DOD Compressor 280A

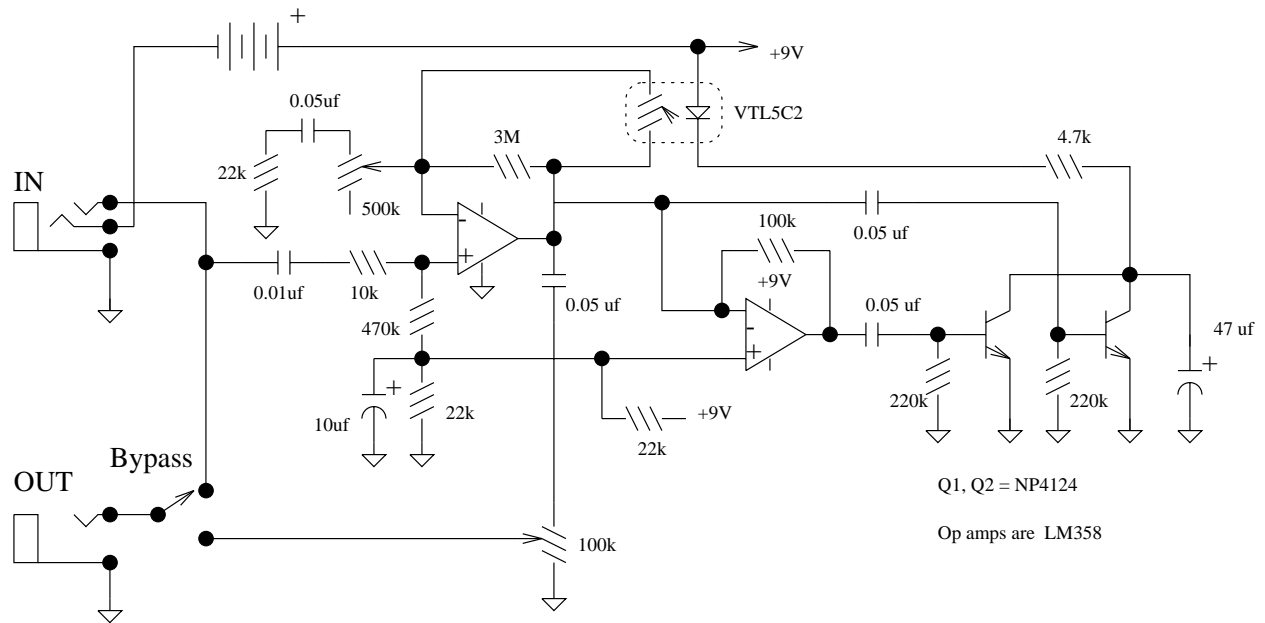
This is the original schematic, but it looks funny to me. I think that there should be a 100k resistor at the (-) input of the second opamp to make it a pure inverter. As it is, that stage would have a very large voltage gain, unbalancing what I think works as a full wave rectifier/current source for the LED in the compression feedback loop. I would expect that the proper circuit is as shown in the fragment below.

I think the VTL5C2 LED/LDR module could be replaced with a CLM6000 if you could find one of those.
